Request For Information - 49

The Cora Apartments (19 W Harrison)

Subject:	**Drainage Details at Planter Locations**	**Status:**	**Open**
Drawing #:	**Attached Sketches, L0001, A0201, A0202**	**Spec Sect #:**	
Addendum:		**Submittal #:**

SHEET NO (SUBSET)
L0001

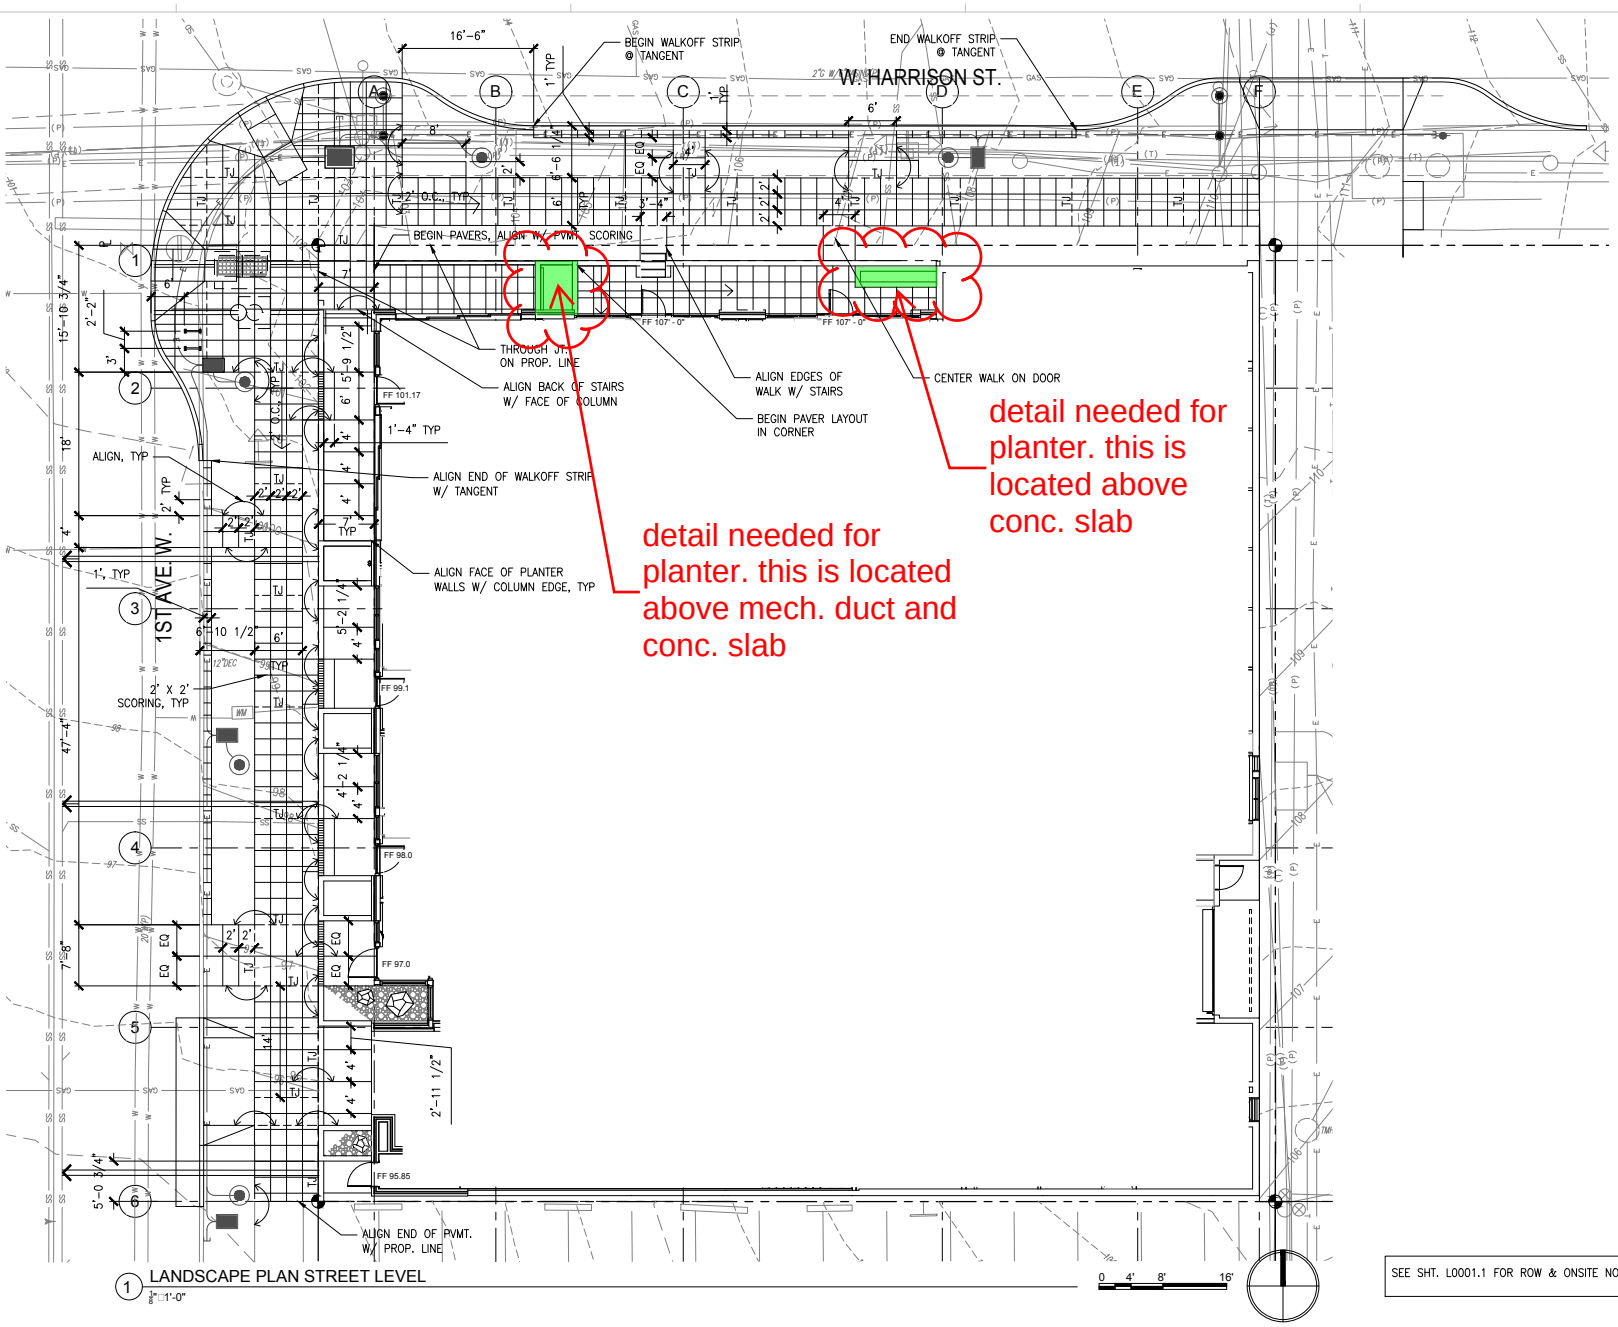
Per the attached sketch and highlighted L0001 drawing, it was confirmed that there is no drain in the bottom of the planter at grid 1 between B and C, and also west of grid D. Please have BEE provide a waterproofing and drain detail.

BEE consulting confirm it is acceptable to install hot rubber in the planter on the topping slab at elevation 104 and 107, and install weep holes in the North wall/curb of the planter to drain into the planting strip, and provide new Arch, struct. BE, details as necessary.

Date	Response
11-08-2016	See attached Partial Building Section, page 6. There is a additional 6" thick concrete slab in the Planter at a height of 104'-0" This upper slab to be slopped to the south. A drain will be 4" off the South planter wall, centered. The lower slab at EL. 100'-7 1/2" will need a drain centered. BEE will provide waterproofing information for the planter with this RFI. JXW

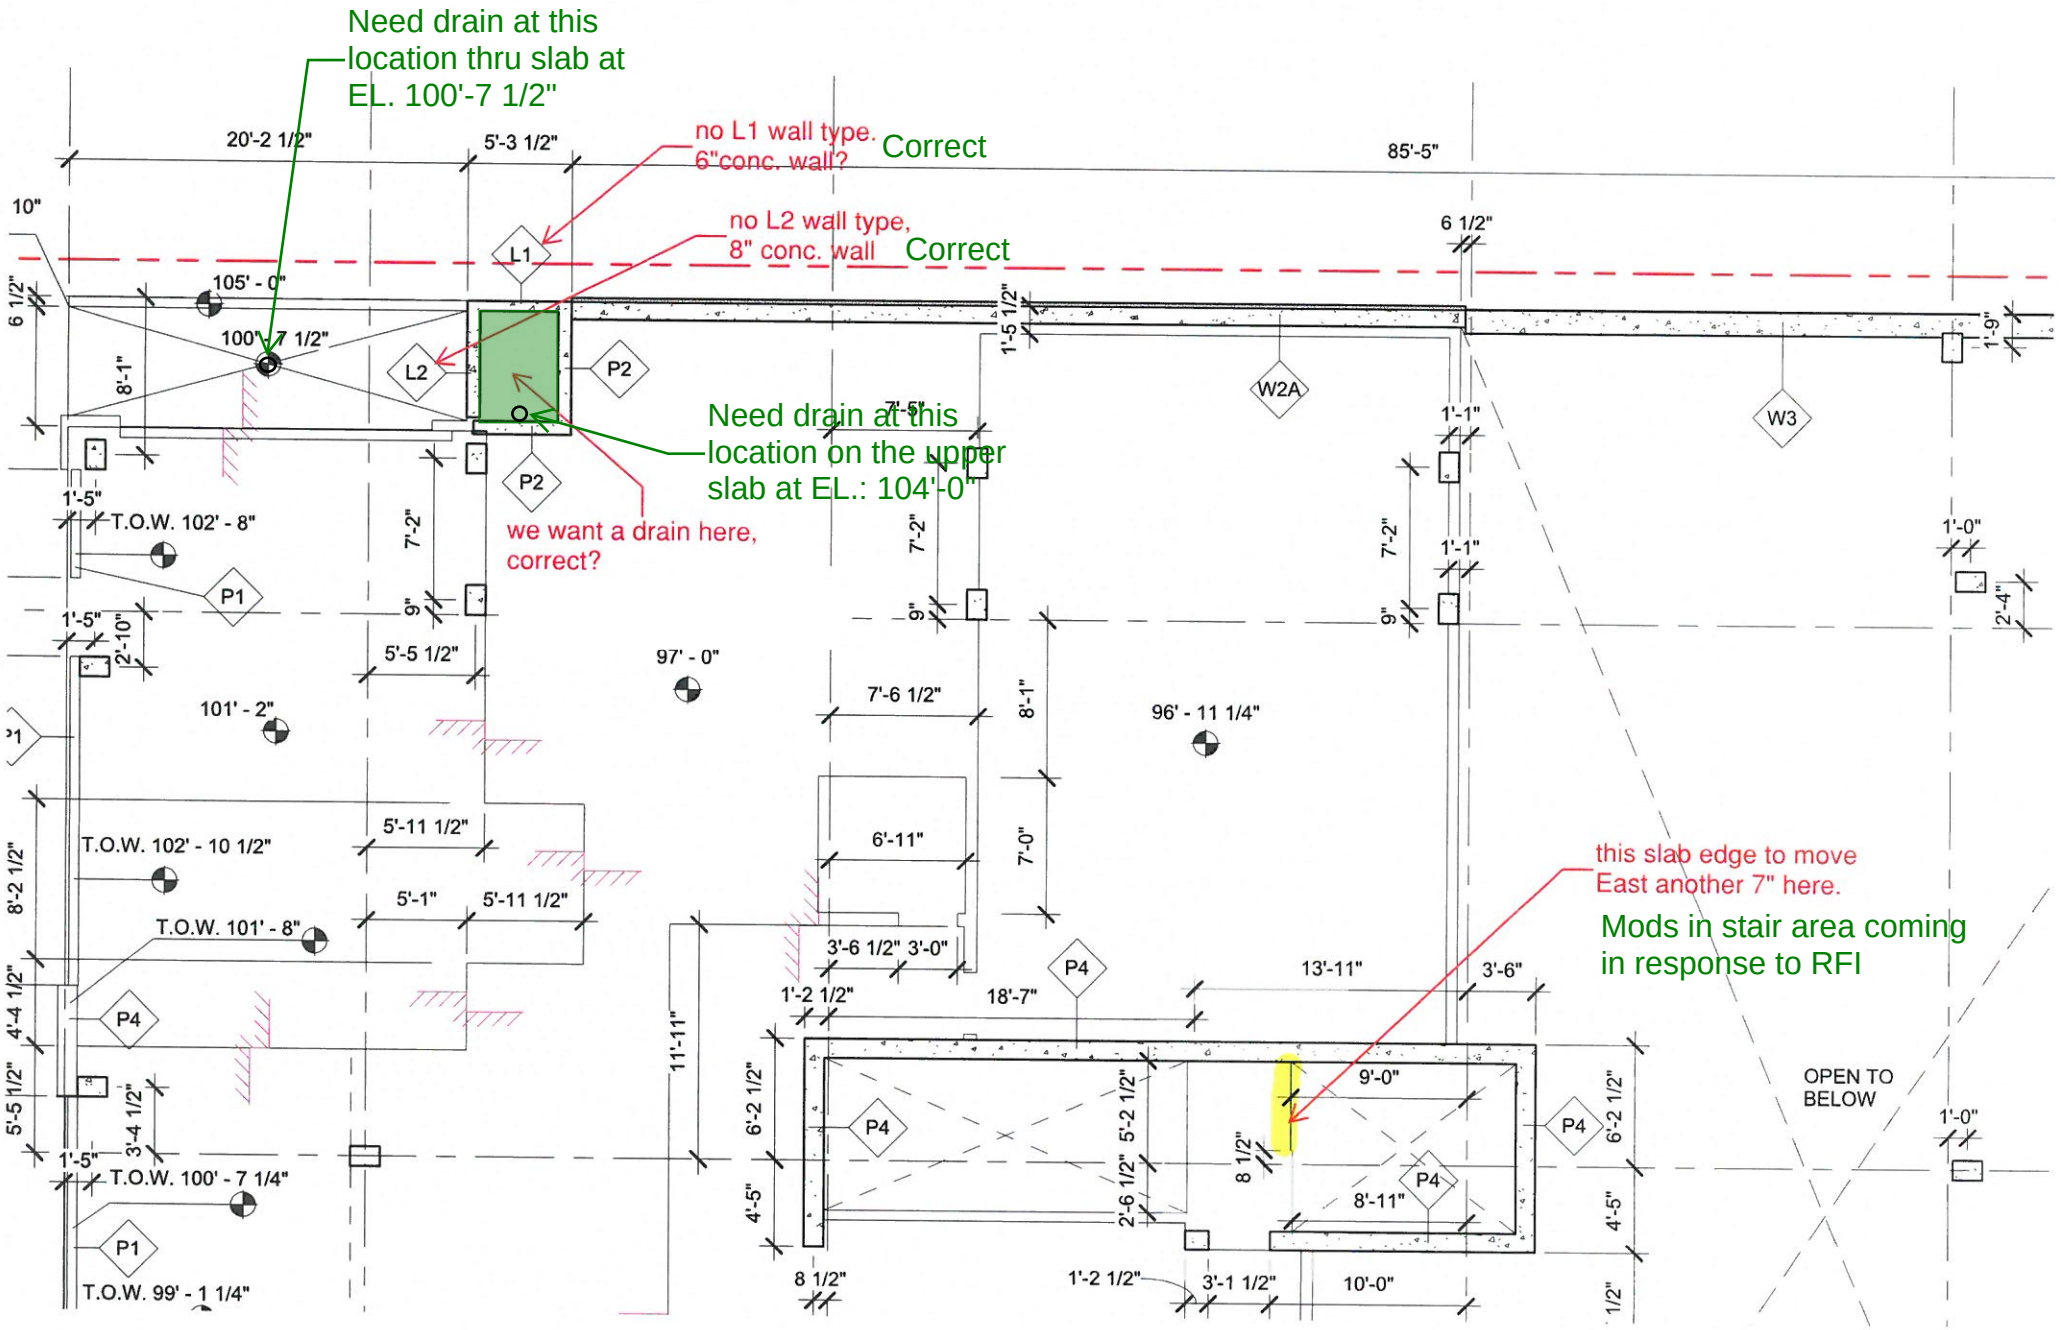
Need drain at this location thru slab at EL. 100'-7 1/2"
no L1 wall type. 6"conc. wall?
Correct
no L2 wall type, 8" conc. wall
Correct
Need drain at this location on the upper slab at EL.: 104'-0"
we want a drain here, correct?
this slab edge to move East another 7" here.
Mods in stair area coming in response to RFI
20'-2 1/2"
5'-3 1/2"
85'-5"
105' - 0"
100' - 7 1/2"
T.O.W. 102' - 8"
101' - 2"
97' - 0"
96' - 11 1/4"
T.O.W. 102' - 10 1/2"
T.O.W. 101' - 8"
T.O.W. 100' - 7 1/4"
T.O.W. 99' - 1 1/4"
OPEN TO BELOW
L1
L2
P1
P2
P4
W2A
W3

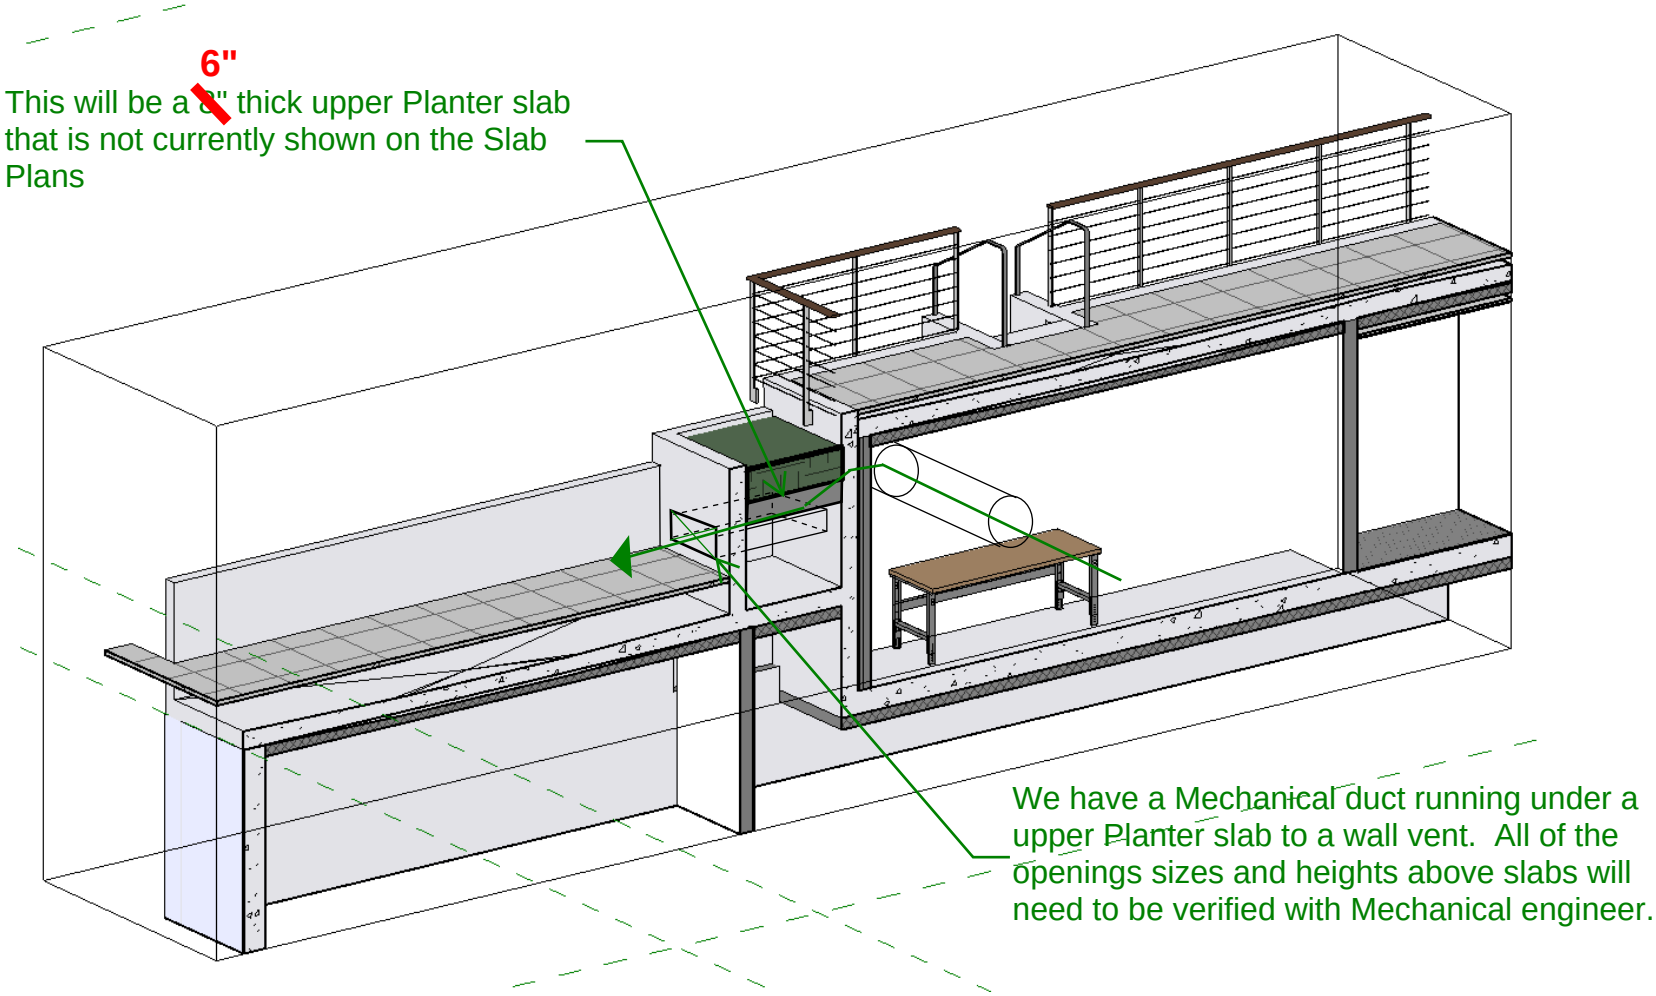
6"
This will be a 8" thick upper Planter slab that is not currently shown on the Slab Plans
We have a Mechanical duct running under a upper Planter slab to a wall vent. All of the openings sizes and heights above slabs will need to be verified with Mechanical engineer.

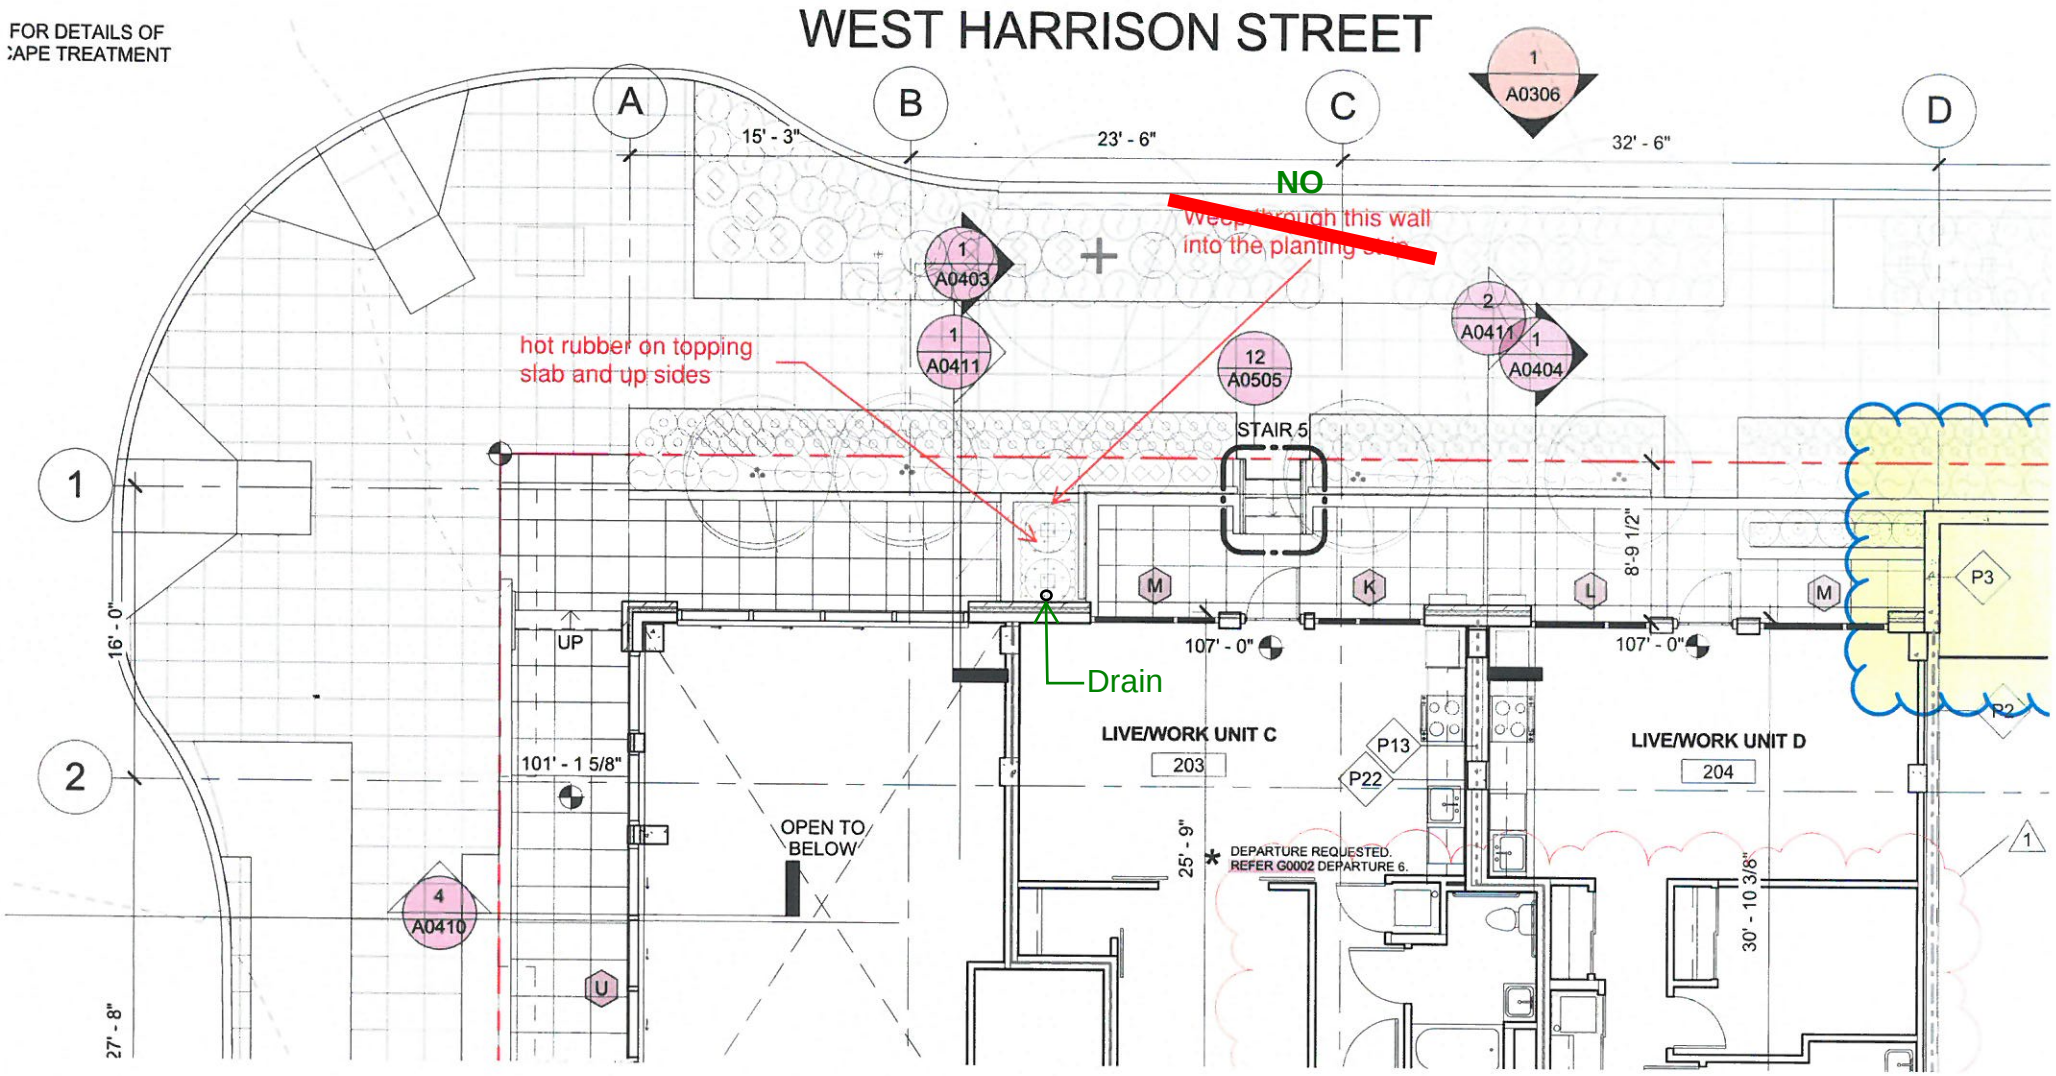
FOR DETAILS OF
CAPE TREATMENT
WEST HARRISON STREET
A
B
C
D
1
2
15' - 3"
23' - 6"
32' - 6"
1
A0306
NO
Weep through this wall
into the planting
1
A0403
1
A0411
12
A0505
2
A0411
1
A0404
hot rubber on topping
slab and up sides
STAIR 5
8'-9 1/2"
M
K
L
M
P3
P2
107' - 0"
107' - 0"
Drain
UP
16' - 0"
101' - 1 5/8"
LIVE/WORK UNIT C
203
P13
P22
LIVE/WORK UNIT D
204
OPEN TO
BELOW
25' - 9"
*
DEPARTURE REQUESTED.
REFER G0002 DEPARTURE 6.
30' - 10 3/8"
1
4
A0410
U
27' - 8"
